**Vestavia Hills  
Design Review Board Agenda  
June 5, 2025  
6:00 PM**

1. Call to Order
2. Roll Call
3. **DRB-25-6** Neil Shah is requesting **Architectural Review, Landscape Review, & Final Review Of Materials** for the property located at 1030 S. Liberty Rd. The purpose of this request is for a new building. The property is owned by Neil Shah and zoned Vestavia Hills PB.

**Design Review Board Application****Applicant****Primary Location****DRB-25-6**

THE GODDARD SCHOOL  
PRE-SCHOOL  
LIBERTY PARK, ALABAMA

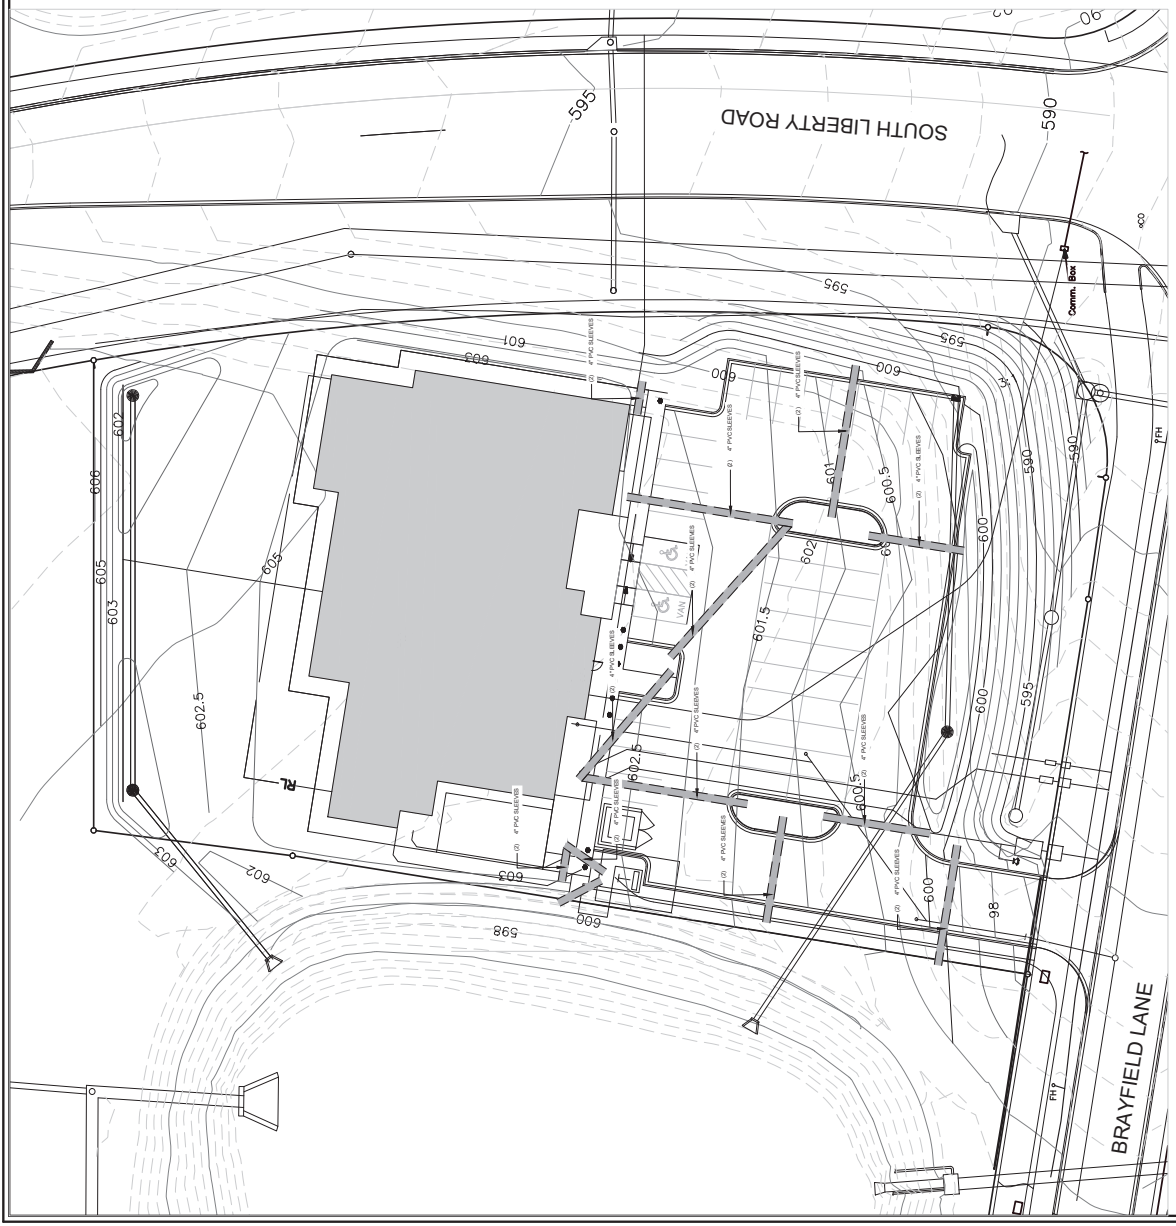
- Approved w/ Comments
- provide physical color sample of monument sign lettering for approval
  - hldg sign on front - legs no more than 36", lettering no higher than 24"
  - provide updated landscape plan to screen play equipment with evergreen plantings
